**ZONING CHANGE REVIEW SHEET**

**CASE:** C14-2016-0115  
2222 Town Lake Circle

**ADDRESS:** 2222 & 2400 Town Lake Circle and 2217 & 22225 Elmont Drive

**REQUEST (ERC PLAN AMENDMENT):**

Identifies the subdistrict for each property within the ERC boundary.

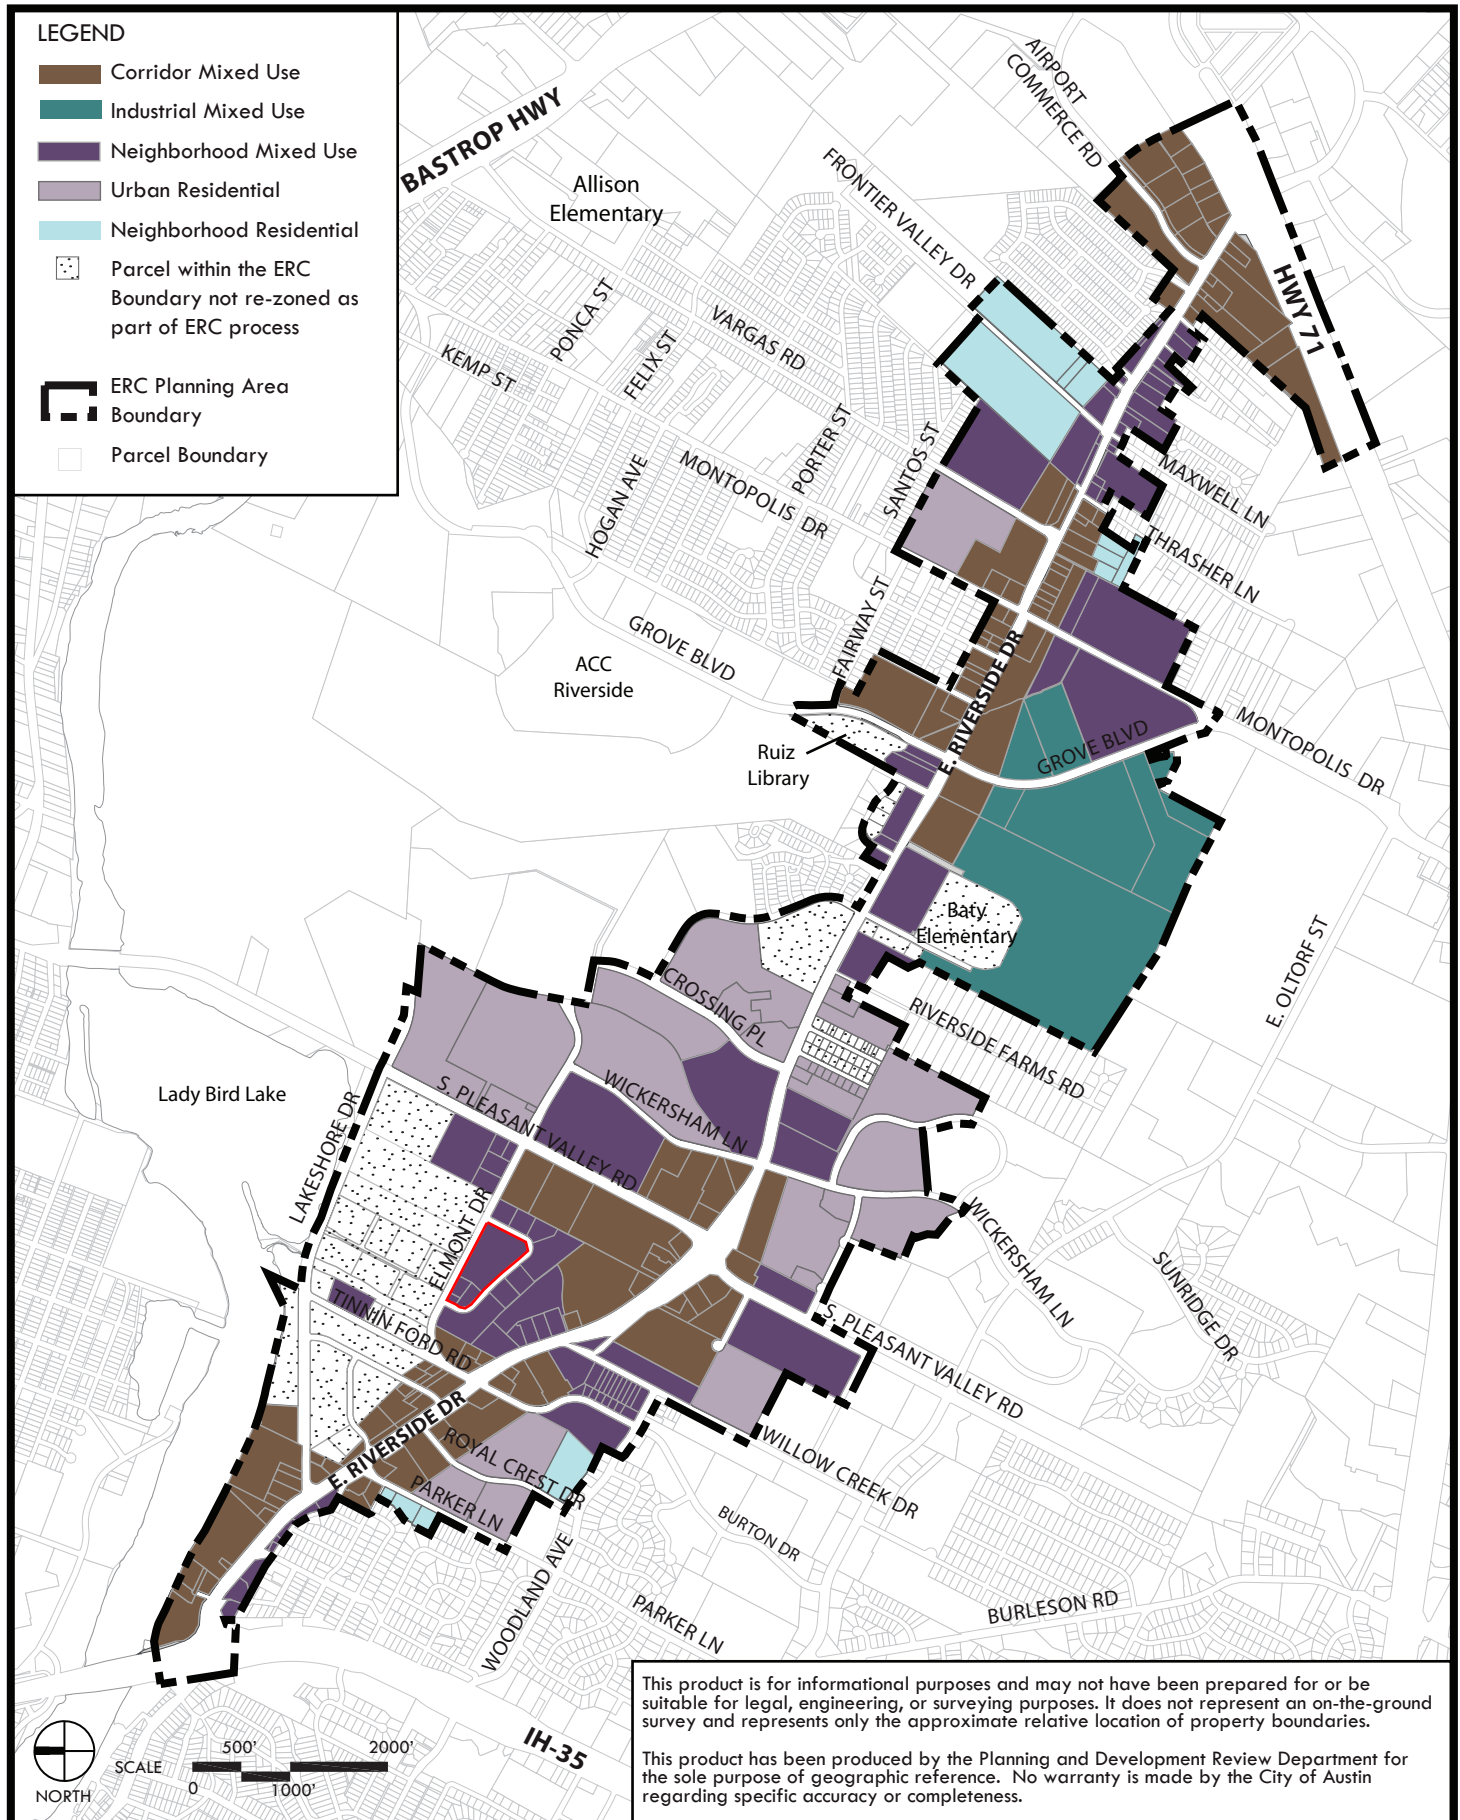
**BASIS FOR RECOMMENDATION****Amendment # 1 / Amendment to the Subdistrict Designation (ERC Plan Figure 1-2)**

The subject tract is currently designated Neighborhood Mixed Use (see Exhibit C – 1). Per the ERC Regulating Plan, Neighborhood Mixed Use (NMU) is a subdistrict between the

Nevertheless, staff recommends the subdistrict designation of Corridor Mixed Use (CMU) for a couple of reasons. First, the current NMU does not permit general retail, thus precluding that option from a mixed-use development, which staff believes will be useful on Ellmont with the completion of the Lakeshore PUD office development and multifamily fronting Ellmont. Although the specific types of commercial envisioned in the project are unknown, staff does not see the need to preclude this variety of retail. Second, Corridor Mixed Use (CMU) allows for an additional height and FAR. The Lakeshore PUD creates what staff

**Given the location of this property adjacent to the Lakeshore PUD and proximity to the two HUBS, staff thinks the designation of the property as a Corridor Mixed Use subdistrict is appropriate. Additionally, staff thinks the property should be included with the Pleasant Valley Transit Plaza Hub and Lakeshore boundary because of its proximity to the future transit stop, and because Elmont Drive has existing bus and bicycle options. Lastly, staff supports designating the property as eligible for development bonus height in exchange for the provision of community benefits. Given the options of 65, 120 and 160 feet as a maximum height, staff supports specification of 120 feet, as requested by the applicant, as the maximum bonus height at this time.**

**FIGURE 1-6: East Riverside Corridor Hub Map**

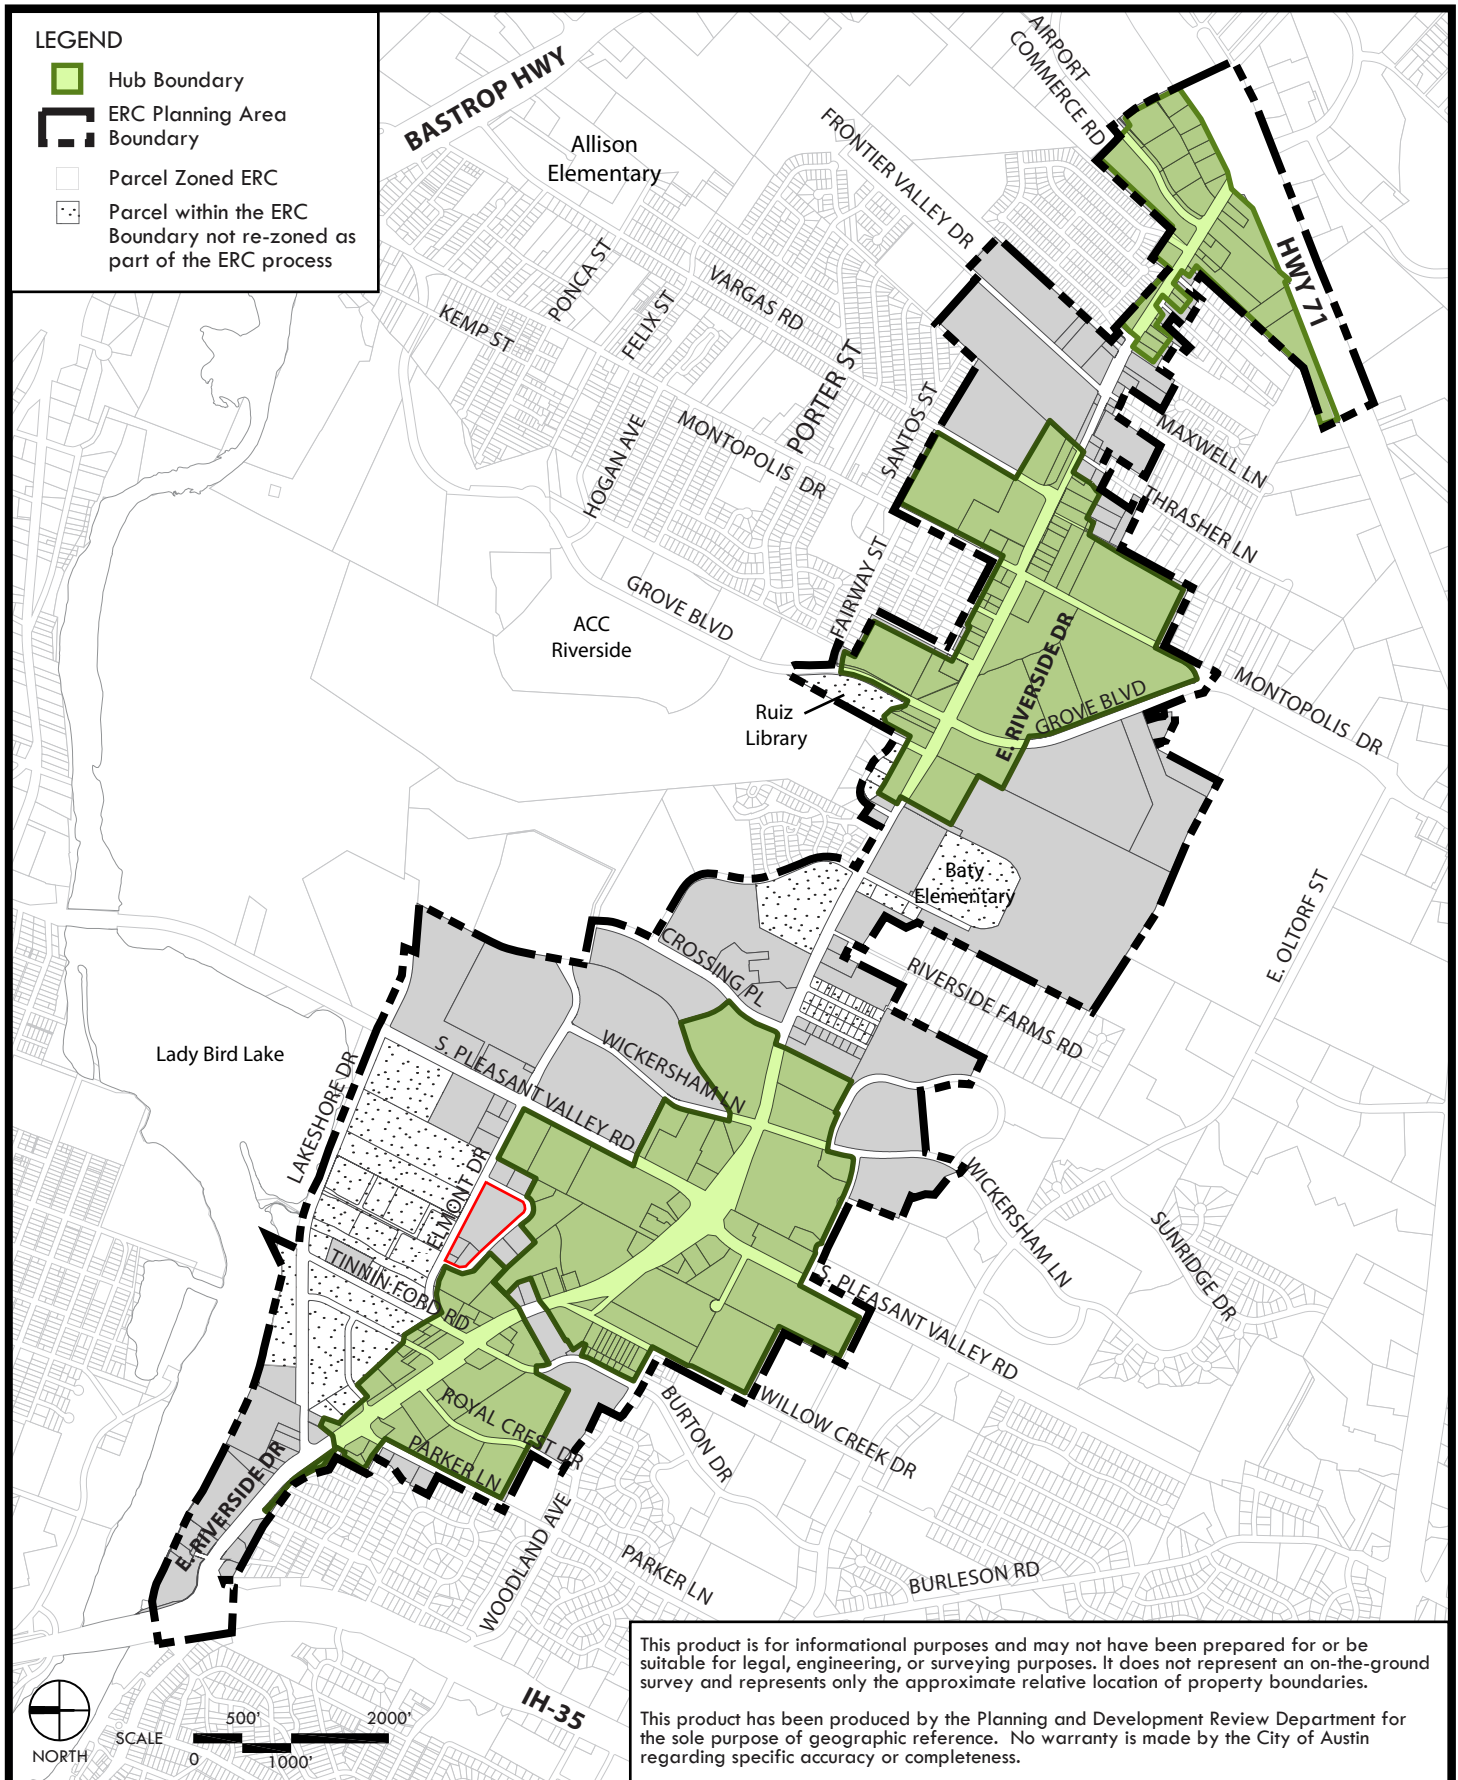
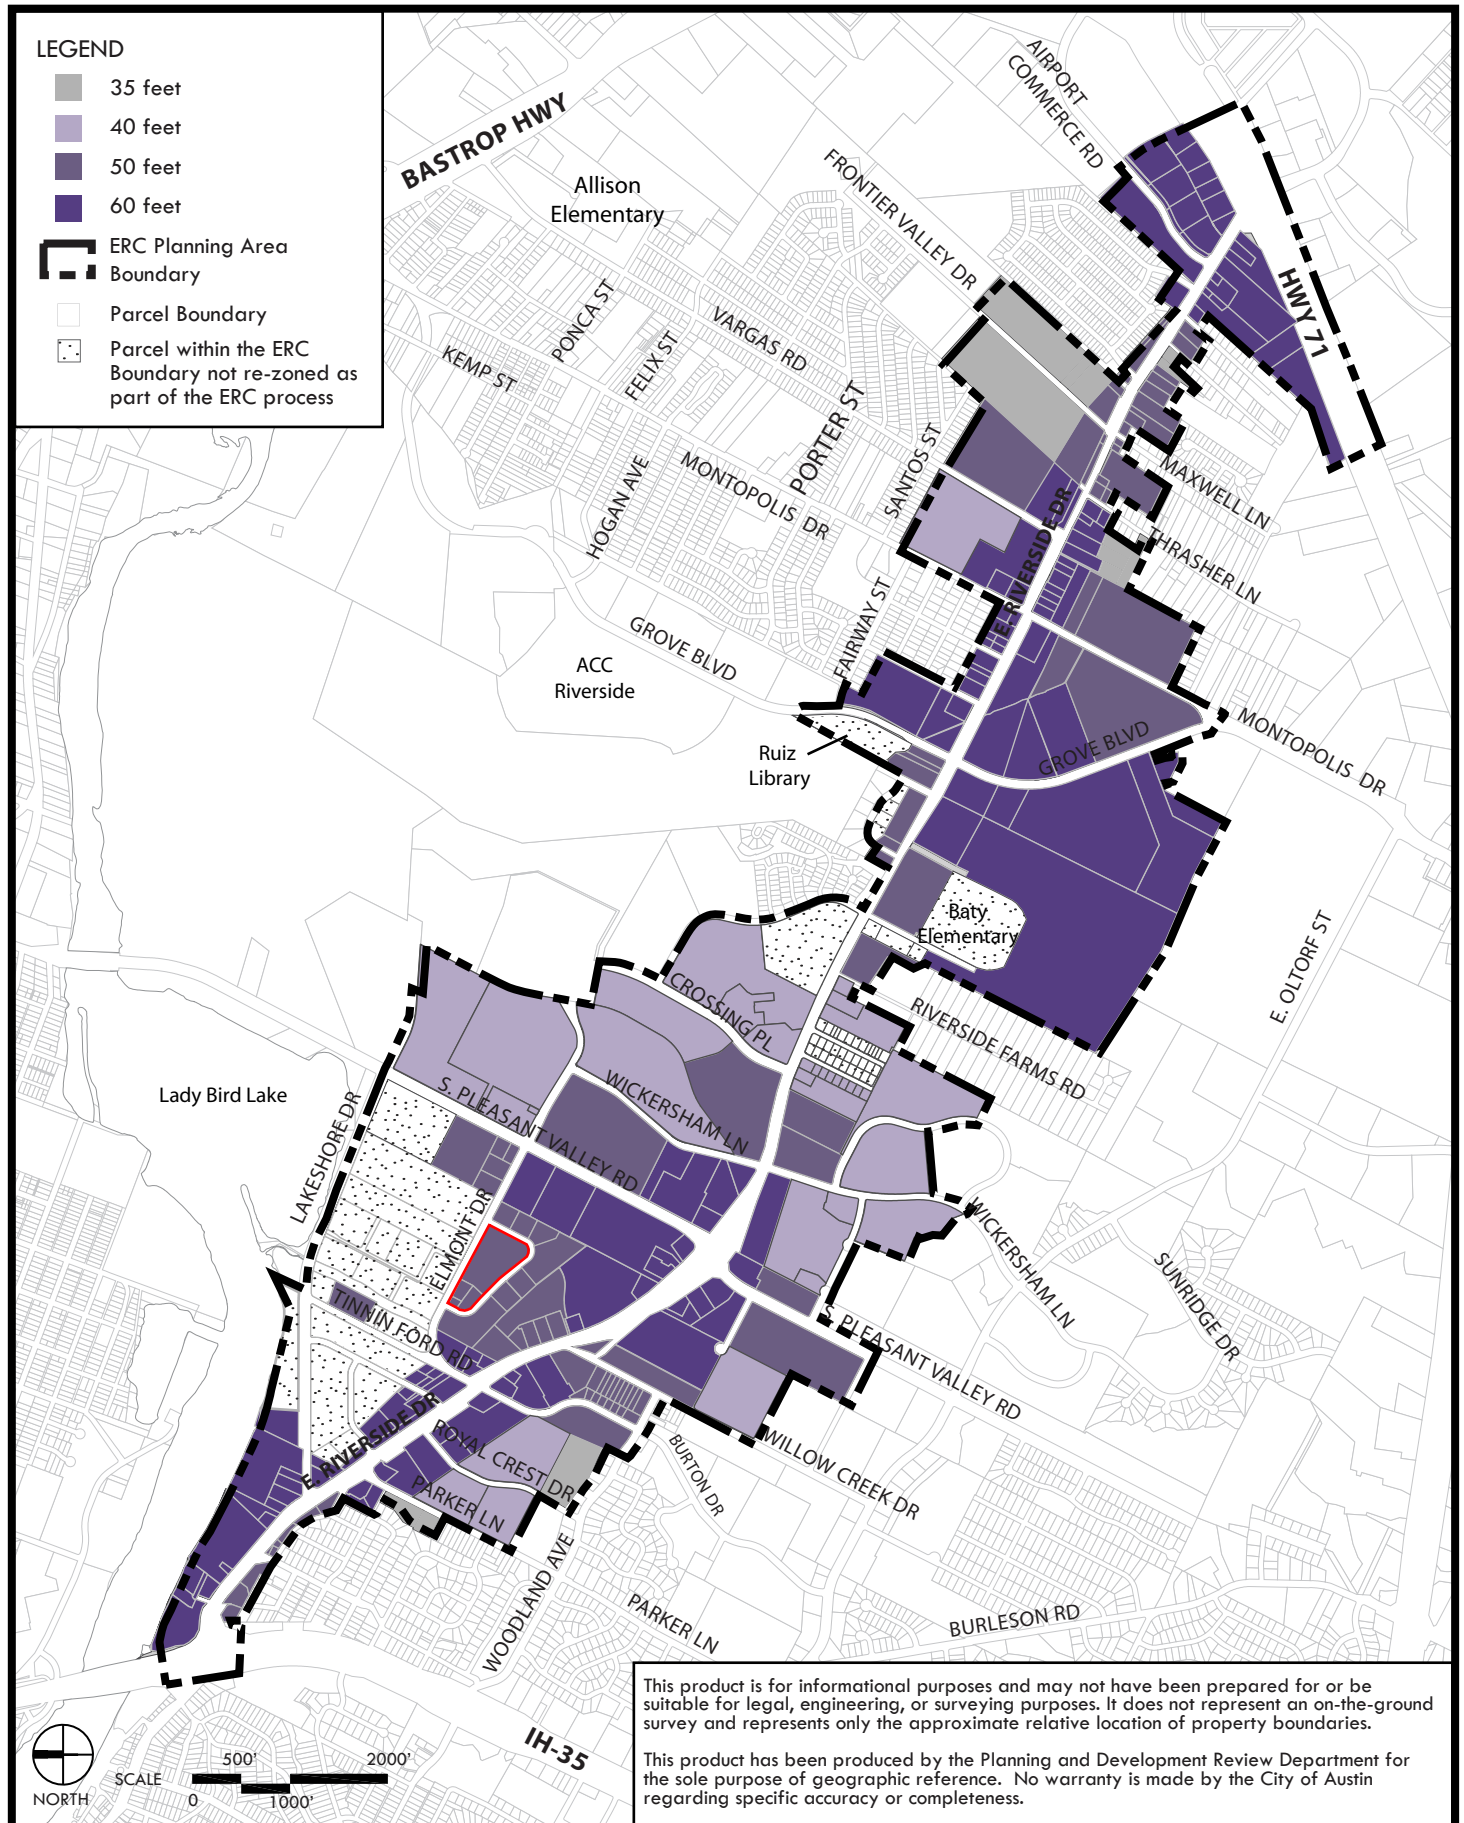
**Amendment # 2 / Amendment to the Hub boundary (ERC Plan Figure 1-6) and  
Amendment # 3 / Amendment to the Maximum Height Available under Development  
Bonus (ERC Plan Figure 1-8)**

The request to be included in a designated Hub is both its own request, but also is a necessary request in order to consider the third request. Per the Regulating Plan, only properties within the Hub boundaries are eligible for development bonuses in exchange for the provision of specified community benefits.

The ERC Regulating Plan designates four Hubs along E. Riverside and other major streets, corresponding to future transit hubs. These are areas in which the most intensive development within the corridor is encouraged (see Figure 1-6). Following the vision set out in the Master Plan, a key purpose of the Regulating Plan is to: promote transit-supportive development and redevelopment within the ERC Hubs in order to successfully integrate land use and transit by providing greater density than the City of Austin average, a mix of uses, and a quality pedestrian environment around defined centers. It follows that Hubs are seen as dense and vibrant or areas where the most intensive development is encouraged, with urban form and uses that require less reliance on the automobile and are more accommodating of pedestrian, transit, and bicycle transportation.

Currently the property is outside the Hub. Only if it is within the Hub can it become eligible for development bonuses. The Regulating Plan provides for additional height or FAR in exchange for community benefits, such as affordable housing, mixed income communities, open space, improved bicycling facilities or improved flood and water quality controls (see Figure 1-8).
